Notice of Allowability

09/653,202

In the title: change the title as "Method of forming a seal pattern comprising bent portions circumventing a conductive contact dot for liquid crystal display device."

(related art)
FIG 2

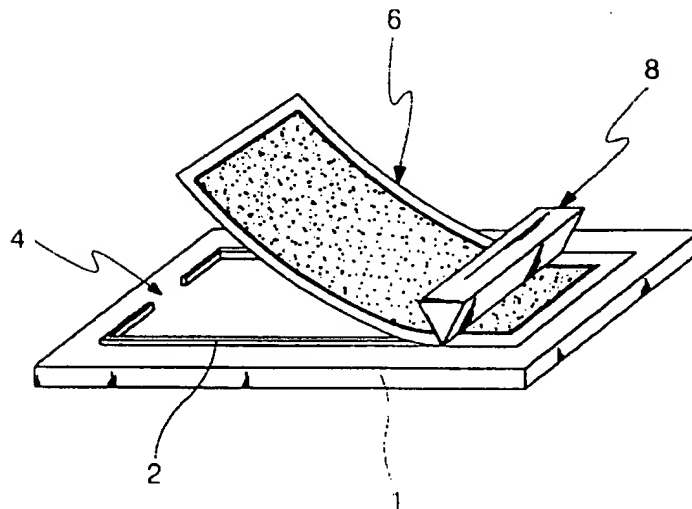
The most revelant reference, US 5,717,476 to Kanazawa, fails to disclose or suggest a seal pattern having a plurality of bent portions with the above dimensions. As shown in Fig. 2, Kanazawa discloses a sealing pattern 6 having a plurality of bent portions without any specific dimensions, wherein the bent portions of the seal pattern 6 are bent toward an inside of the second substrate 2, and each bent portion circumvents a conductive contact dot 10.
